Access Compliance Report

Public Rights-of-Way

(Curb Ramps)

Intersection ID: 22358	Main Street: HINSON_DR	Cross Street: TADLOCK_PL	Location: NE
ADA ID: 87DE26F80D68	Ramp Type: PerpDiag	Initial Pass/Fail: Fail	Overall Compliance: No
		Severity Score: 50

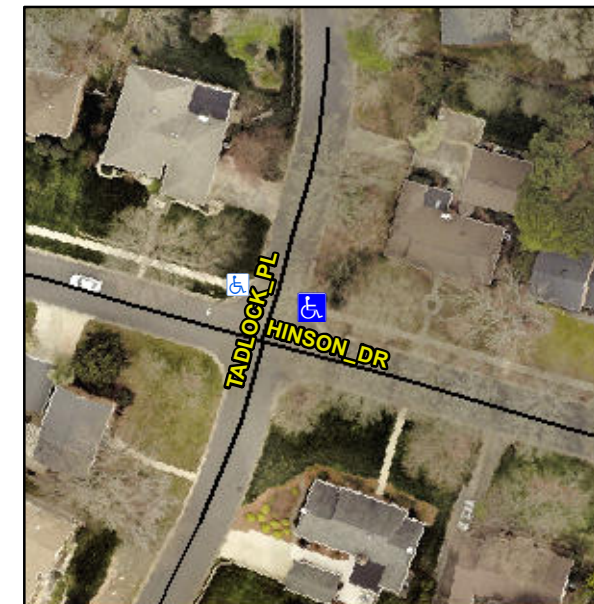
Not Found, R304.2.2, R304.5.3

Compliance	Description	Data	Compliance	Description	Data
N/A	Ramp Length (in)	55.0	No	Ramp Slope (%)	14.5
Yes	Ramp Width (in)	48.0	No	Ramp XSlope (%)	8.9
N/A	Flare Type LT	N/A	N/A	Flare Type RT	N/A
N/A	Flare Slope LT (%)	N/A	N/A	Flare Slope RT (%)	N/A
N/A	Flare Traversable LT?	N/A	N/A	Flare Traversable RT?	N/A
N/A	Landing Length (in)	N/A	N/A	DWS Provided?	N/A
N/A	Landing Width (in)	N/A	N/A	DWS Contrast?	N/A
N/A	Landing Slope (%)	N/A	N/A	DWS Length (in)	N/A
N/A	Landing X Slope (%)	N/A	N/A	DWS Full Width?	N/A
N/A	Landing Curb? (Y/N)	N/A	N/A	DWS Offset (in)	N/A
N/A	Shared Landing?	N/A			
N/A	Gutter Ponding?	N/A	N/A	Gutter Slope (%)	N/A
N/A	Gutter Lip Ht (in)	N/A	N/A	Gutter X Slope (%)	N/A
N/A	Painted X Walk1?	No	N/A	Painted X Walk2?	No
	X Walk 1 Direction	To NW		X Walk 2 Direction	To SW
N/A	X Walk 1 Width (in)	N/A	N/A	X Walk 2 Width (in)	N/A
	X Walk 1 Slope (%)	0.4		X Walk 2 Slope (%)	0.3
	X Walk 1 X Slope (%)	3.0		X Walk 2 X Slope (%)	0.7

Remove & Replace Curb Ramp With Two New Directional Ramps or Equivalent.
